Docket No. 50-219

Change No. 1
 License No. DPR-16

SAFETY EVALUATION BY THE DIVISION OF REACTOR LICENSING

PROPOSED CHANGE NO. 1 TO TECHNICAL SPECIFICATIONS

FIGURE TS-1 FUEL CLADDING INTEGRITY SAFETY LIMIT.

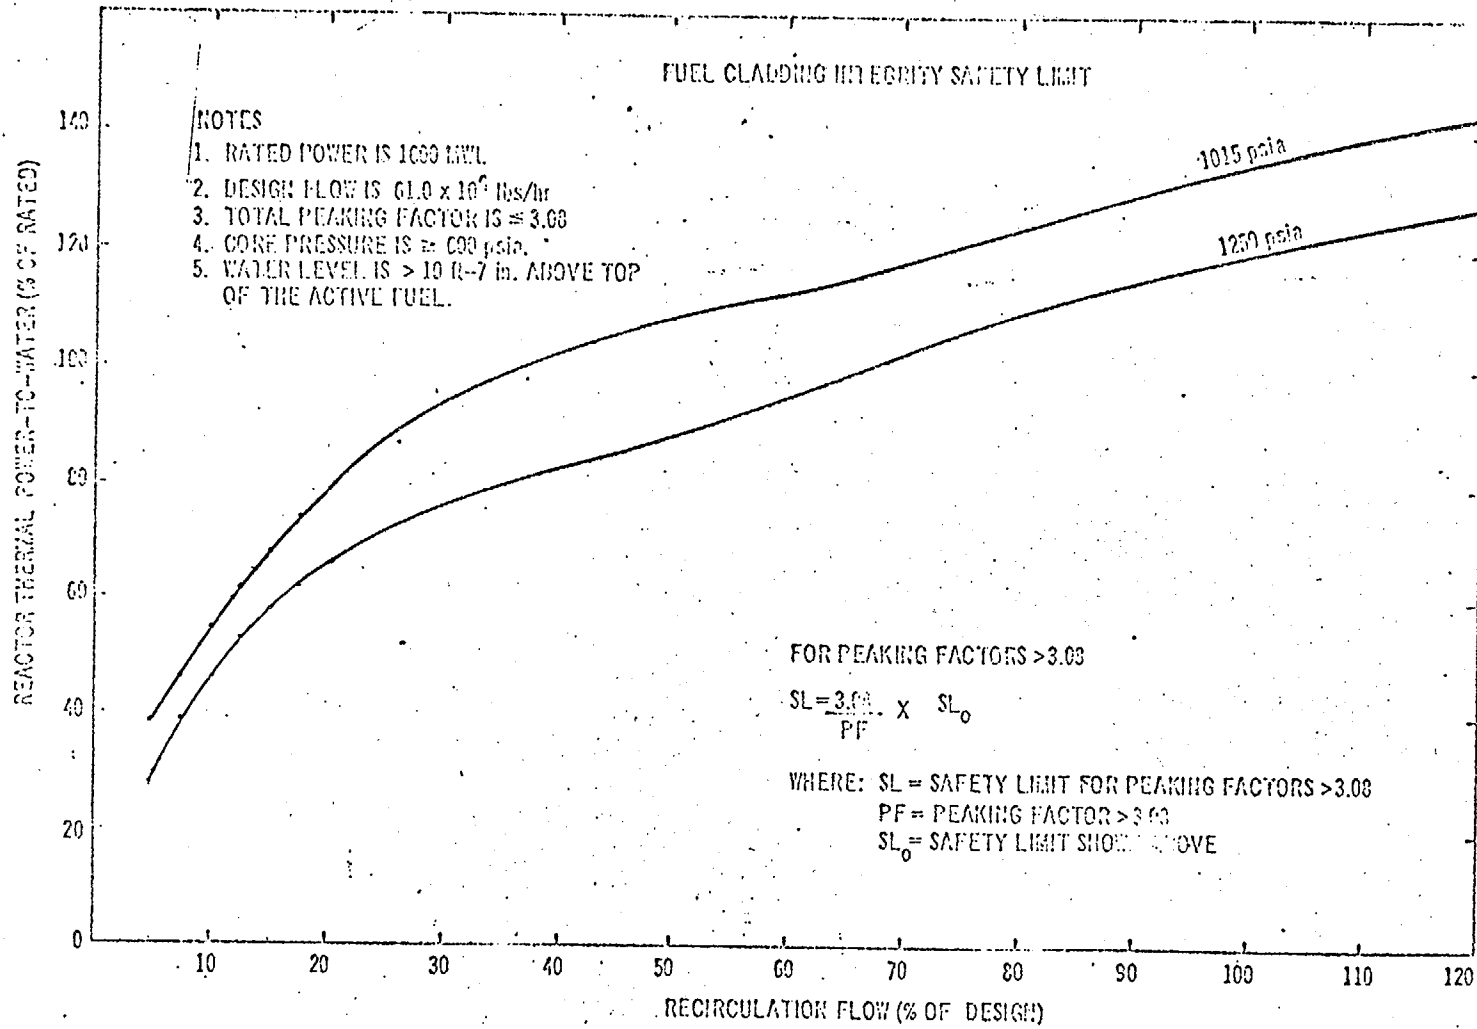
We have reviewed your Change Request No. 1 dated November 11, 1969, and Supplement No. 1 dated November 12, 1969, requesting a change to Figure 2.1.1 and Section 2.1.B of the Technical Specifications to Provisional Operating License No. DPR-16. The proposed change would extend the fuel cladding safety limit, based on a minimum critical heat flux ratio of 1.0, to include the region of operation between 5% core coolant flow and 20% core coolant flow.

Accordingly, Figure 2.1.1 is replaced by the attached Figure TS-1 and Section 2.1.B is changed to read:

Recent data taken at the Oyster Creek reactor indicate that natural circulation flow may be less than had been expected. As a result, during the transient following a five-pump trip, reactor flow may be as low as 15% when 21% power is achieved. The proposed safety limit, based on the critical heat flux correlation of APED-3892, establishes a limit which would permit operation with as little as 5% flow between 20% and 30% power. Below 5% flow, the safety limit would be established at 20% power.

"B. When the reactor pressure is less than 600 psia or reactor flow is less than 5 percent of design, the reactor thermal power shall not exceed 320 Mwt."
